E/ECE/324
E/ECE/TRANS/505 } Add.6/Rev.2/Amend.1
4 March 1994

Addendum 6 – Regulation No. 7

Revision 2 – Amendment 1

UNIFORM PROVISIONS CONCERNING THE APPROVAL OF FRONT AND REAR POSITION (SIDE) LAMPS, STOP-LAMPS AND END-OUTLINE MARKER LAMPS FOR MOTOR VEHICLES (EXCEPT MOTOR CYCLES) AND THEIR TRAILERS

In the figure "Minimum horizontal angles of light distribution in space," amend the title of the third diagram "Stop lamps" to read "Stop lamps (S1 and S2)" and add a new fourth diagram to read:

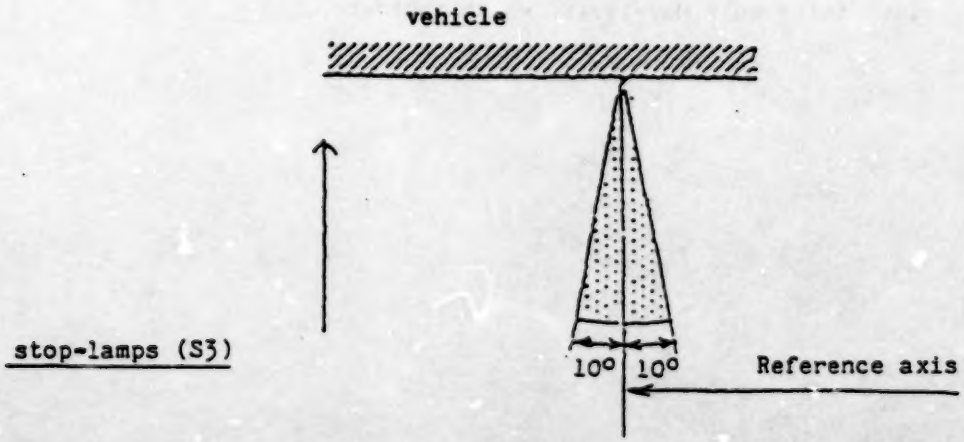
"The minimum vertical angles of light distribution in space are 15° above and 15° below the horizontal for all categories of devices included in this Regulation except for category S3 stop lamp for which they are 10° above and 5° below the horizontal."
